UNITED STATES PATENT AND TRADEMARK OFFICE

APPLICATION NO.	FILING DATE	FIRST NAMED INVENTOR	ATTORNEY DOCKET NO.	CONFIRMATION NO.
09/819,593	03/27/2001	Kenneth Jenks	PALM-3583.US.P	3487

Office Action Summary

FIG. 5 of Brick et al.

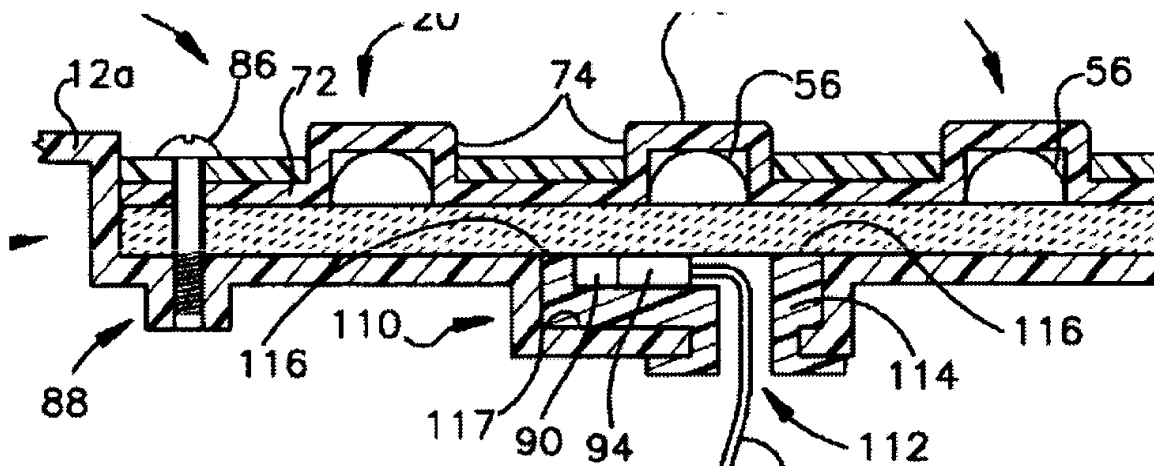
a button frame module 80 (see fig. 5) formed with a vertical cavity to align with the button 56;

a membrane layer 72 disposed on the outer side (reference 74) of the button frame 80 and covering the vertical cavity; and

Regarding claims 13, 14 and 29, Brick et al. teaches the button module removably coupled to a top cover 12 (fig. 5) of the personal digital assistant (PDA, col. 1, line 15).

Applicants argue, “Brick reference does not teach or suggest a removable button module having a membrane layer disposed above the button frame module as specified in amended claim 1.” The examiner respectfully disagrees. Brick et al. teaches a removable button frame 80 (fig. 5, a portion shown below) with a membrane layer 72 (comprising of 72 and 74) with membrane portion 74 disposed above the button frame 80.
